8XC251Sx (8XC251SA, SB, SP, SQ) SPECIFICATION UPDATE

Release Date: December, 1998

Order Number: 272836-007

Figure 1. External Code Fetch, Nonpage Mode

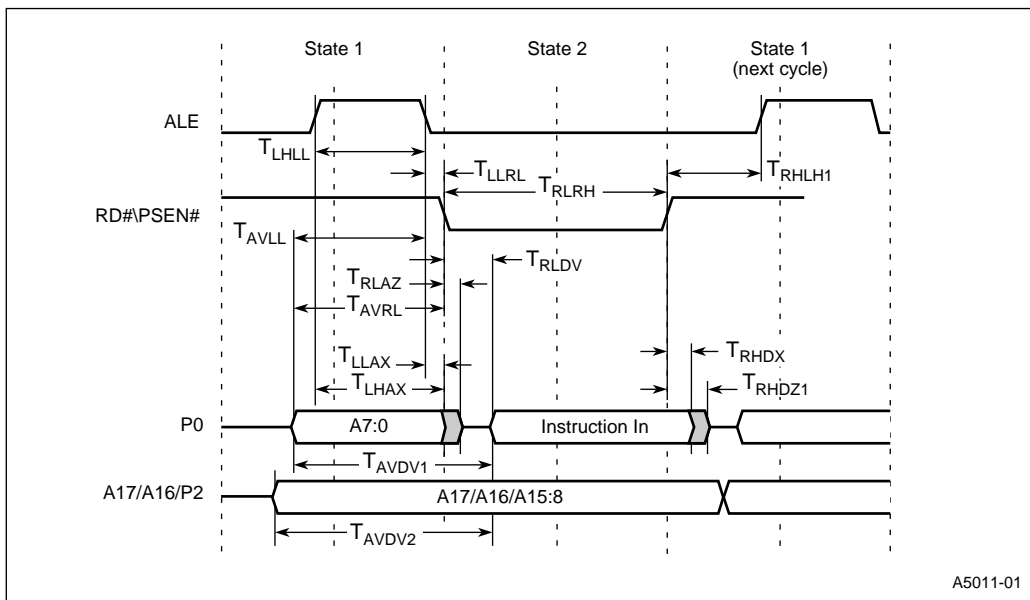
PROBLEM: The TRHDZ1 (Instruction Float After RD#/PSEN# High) specification on the 8XC251Sx when operating at 12 MHz is 10 ns. However, a slow memory device such as an EPROM typically takes approximately 30 – 90 ns to float its output. (This specification generically called TPHZ, may vary from one manufacturer to another.) and illustrate the TRHDZ1 timing.

The difference between the TRHDZ1 and TPHZ specifications causes contention on the data bus (P0 in nonpage page, P2 in page mode). The 8XC251Sx begins to drive the address for the next bus cycle while the memory device is still driving data from the previous bus cycle.

To prevent this contention, designers can use a buffer to isolate the output of the memory device from the data bus (port 0 or port 2) of the 8XC251Sx. This will prevent the slow memory device from driving the data bus during the critical period after TRHDZ1 expires. We suggest a buffer such as the 74F541 octal, three-state line driver shown in Figure 3.
